**Re: Site C Clean Energy Project Decision Statement – Change to Capacity of Generating Units**

**Memo: Evaluating the Impact of As-built Plant Characteristics on the Site C Clean Energy Project**

**AMENDMENT #12 (AMENDMENT) TO  
ENVIRONMENTAL ASSESSMENT CERTIFICATE #E14-02**

**Figure 2.** Simulated Forebay Elevations – EIS (blue) versus As-built units (red)

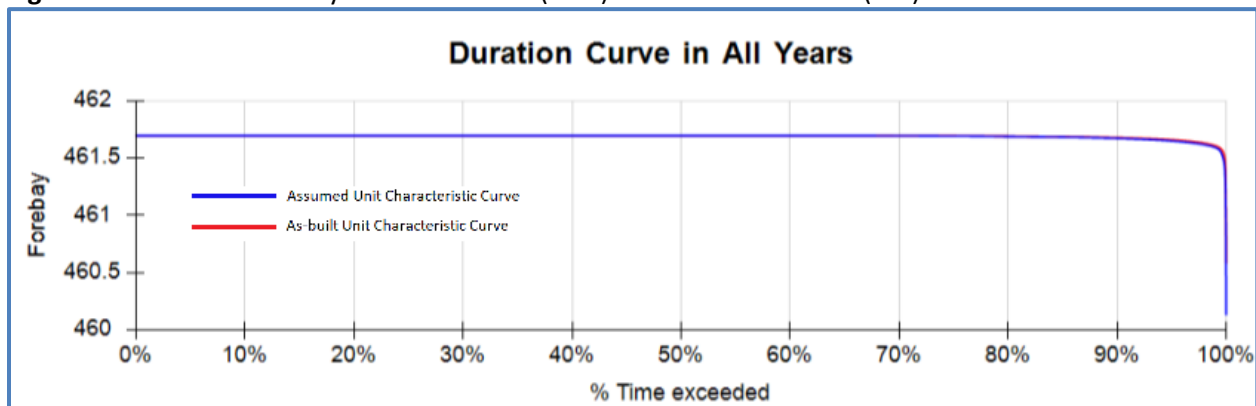
**Figure 2 shows that the reservoir (forebay) levels during operations with the as-built units are expected to be the same as those described in the EIS (i.e., the red line is the same as the blue line).**

The model results show the reservoir being operated within 0.6 m of its maximum operating level of elevation 461.8 m (461.8 m) over 99% of the time.

**Figure 3.** Simulated Total Discharge - EIS (blue) versus As-built units (red)

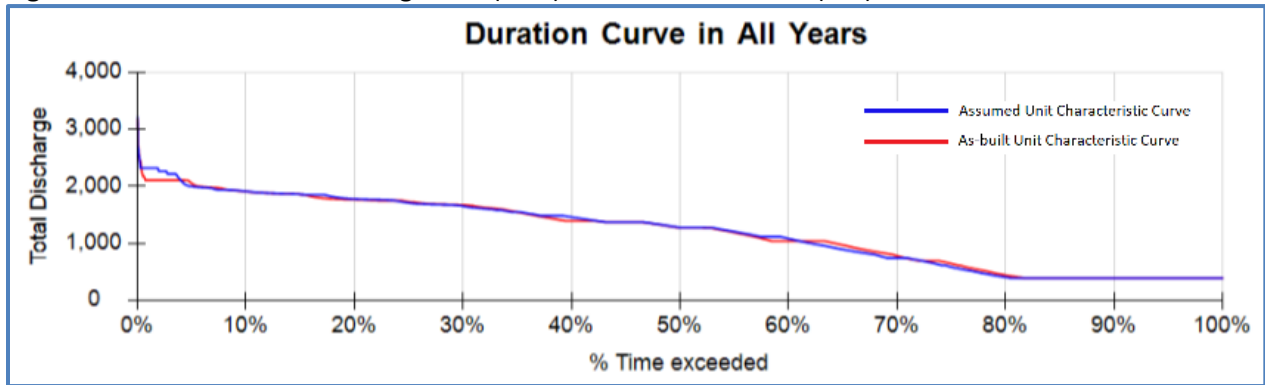
**Figure 3 shows that the total discharge levels during operations with the as-built units are expected to be largely identical to those described in the EIS (i.e., the red line mostly matches the blue line).**

Operations with the as-built units are expected to result in a total discharge of approximately 2,100 m<sup>3</sup>/s for somewhat more time than operations with the EIS units. A total discharge at that level reflects a point of “peak” operational efficiency when all six as-built units are making the most amount of power

The model also shows other small differences in the total discharge levels between operations with the as-built units versus the EIS units. Over time, the total flow of water entering the facility must equal the total flow of water discharging from the facility. The amount of time the facility operates with a discharge of 2,100 m<sup>3</sup>/s therefore influences the amount of time operations will be at other total discharge levels. These differences in total discharge over time are reflected by the differences in the “as built” and EIS (“assumed”) lines on the figure.

**Figure 4.** Simulated Spills - EIS (blue) versus As-built units (red)

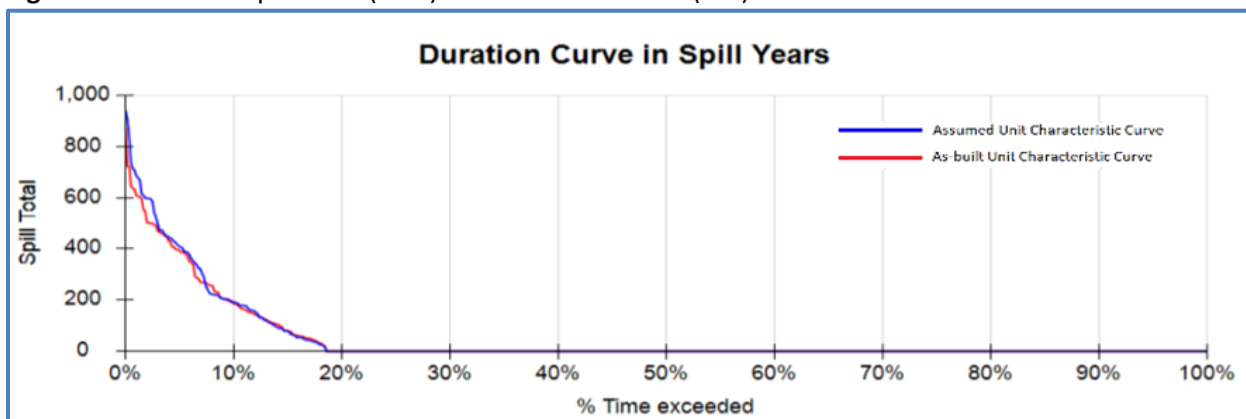
Figure 4 shows that spills from the Site C reservoir are also expected to be similar, and overall slightly lower, than those described in the EIS (i.e., the red line is similar to the blue line).

This is consistent with the as-built units having higher capacity than those assumed in the EIS modelling. Note that Figure 4 shows data only for the 5 out of 60 years for which spills occurred. For all other years, the spill flow was zero.

Figure11: Envelope of site spills modelled by GOM considering Assumed and As-built unit characteristic curves.

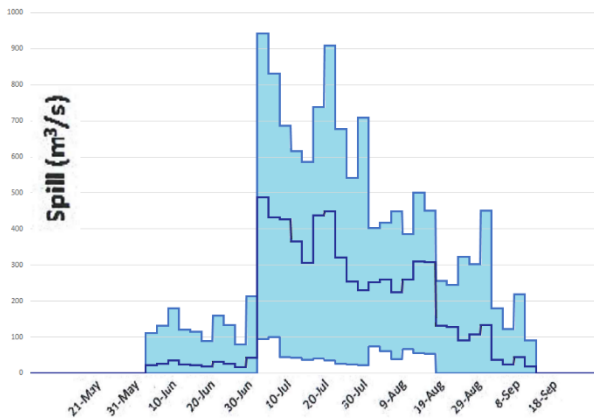
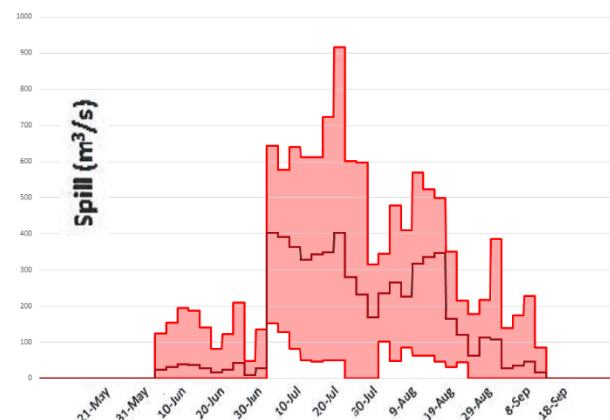
As illustrated in the Figure 11, the envelopes of the two spill curves cover approximately the same area. This indicates that there is no significant impact on the overall system operations.
